Access Compliance Report

Public Rights-of-Way

(Curb Ramps)

Intersection ID: 11677	Main Street: W_11TH_ST	Cross Street: N_TRYON_ST	Location: N
ADA ID: 63E96545E68E	Ramp Type: BlendTrans1	Initial Pass/Fail: Pass	Overall Compliance: No
			Severity Score: 0.25

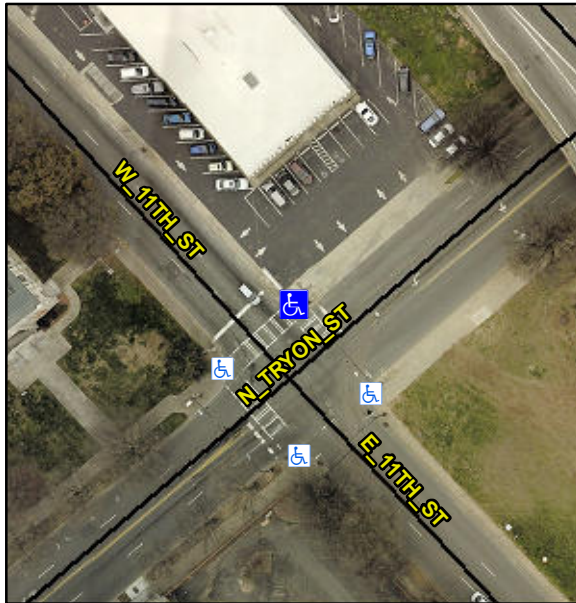
R304.5.3, R305.2

Compliance	Description	Data	Compliance	Description	Data
N/A	Ramp Length (in)	68.0	Yes	BlendTrans Slope (%)	2.2
Yes	Ramp Width (in)	56.0	Yes	BlendTrans XSlope (%)	2.4
N/A	Flare Type LT	Sloped	N/A	Flare Type RT	Sloped
Yes	Flare Slope LT (%)	0.8	N/A	Flare Slope RT (%)	1.0
N/A	Flare Traversable LT?	Yes	N/A	Flare Traversable RT?	No
Yes	Landing Length (in)	60.0	Yes	DWS Provided?	Yes
Yes	Landing Width (in)	60.0	Yes	DWS Contrast?	Yes
Yes	Landing Slope (%)	0.3	Yes	DWS Length (in)	24.0
No	Landing X Slope (%)	14.0	Yes	DWS Full Width?	Yes
N/A	Landing Curb? (Y/N)	No	No	DWS Offset (in)	2.5
N/A	Shared Landing?	No			
Yes	Gutter Ponding?	No	Yes	Gutter Slope (%)	4.0
Yes	Gutter Lip Ht (in)	0.0	No	Gutter X Slope (%)	4.7
N/A	Painted X Walk1?	Yes	N/A	Painted X Walk2?	Yes
	X Walk 1 Direction	To SW		X Walk 2 Direction	To SE
	X Walk 1 Width (in)	110.0		X Walk 2 Width (in)	113.0
	X Walk 1 Slope (%)	4.6		X Walk 2 Slope (%)	7.3
	X Walk 1 X Slope (%)	5.4		X Walk 2 X Slope (%)	1.6

Yes	Ramp inside XWalk1?	Yes	Yes	Ramp inside XWalk2?	Yes
	Road Slope (%)	4.5		Clear Space?	Yes
	Road X Slope (%)	6.3	Yes	Clear Space to XWalk (in)	70.0
Yes	Any Obstructions?	No	Yes	Storm Grate/Utility Hazard?	No
	Obstruction Type			Storm Grate/Utility Type	
		N/A			N/A
			Yes	Surface Condition? (G/P)	Good
			Yes	Curb Slope (%)	0.5

Remove & Replace Curb Ramp With Two New Directional Ramps or Equivalent. Remove & Replace Gutter.
